Access Compliance Report

Public Rights-of-Way

Intersection ID: 23363	Main Street: CARNOUSTIE_LN	Cross Street: QUAIL_HOLLOW_RD	Location: W
ADA ID: 2310C74D8F1B	Ramp Type: PerpDiag	Initial Pass/Fail: Fail	Overall Compliance: No
Severity Score: 12.5			
Codes/Mitigation Info/Possible Solution		Field Measurements/Component Compliance

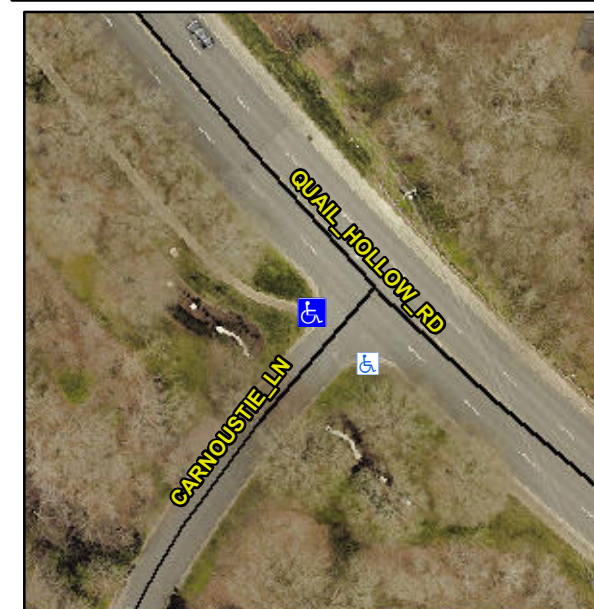
Not Found, R304.5.3

Compliance	Description	Data	Compliance	Description	Data
N/A	Ramp Length (in)	57.0	Yes	Ramp Slope (%)	5.3
Yes	Ramp Width (in)	48.0	No	Ramp XSlope (%)	6.5
N/A	Flare Type LT	N/A	N/A	Flare Type RT	N/A
N/A	Flare Slope LT (%)	N/A	N/A	Flare Slope RT (%)	N/A
N/A	Flare Traversable LT?	N/A	N/A	Flare Traversable RT?	N/A
N/A	Landing Length (in)	N/A	N/A	DWS Provided?	N/A
N/A	Landing Width (in)	N/A	N/A	DWS Contrast?	N/A
N/A	Landing Slope (%)	N/A	N/A	DWS Length (in)	N/A
N/A	Landing X Slope (%)	N/A	N/A	DWS Full Width?	N/A
N/A	Landing Curb? (Y/N)	N/A	N/A	DWS Offset (in)	N/A
N/A	Shared Landing?	N/A			
N/A	Gutter Ponding?	N/A	N/A	Gutter Slope (%)	N/A
N/A	Gutter Lip Ht (in)	N/A	N/A	Gutter X Slope (%)	N/A
N/A	Painted X Walk1?	No	N/A	Painted X Walk2?	No
	X Walk 1 Direction	To SE		X Walk 2 Direction	To NE
N/A	X Walk 1 Width (in)	N/A	N/A	X Walk 2 Width (in)	N/A
	X Walk 1 Slope (%)	0.8		X Walk 2 Slope (%)	7.0
	X Walk 1 X Slope (%)	6.5		X Walk 2 X Slope (%)	0.4

Remove & Replace Curb Ramp With Two New Directional Ramps or Equivalent.
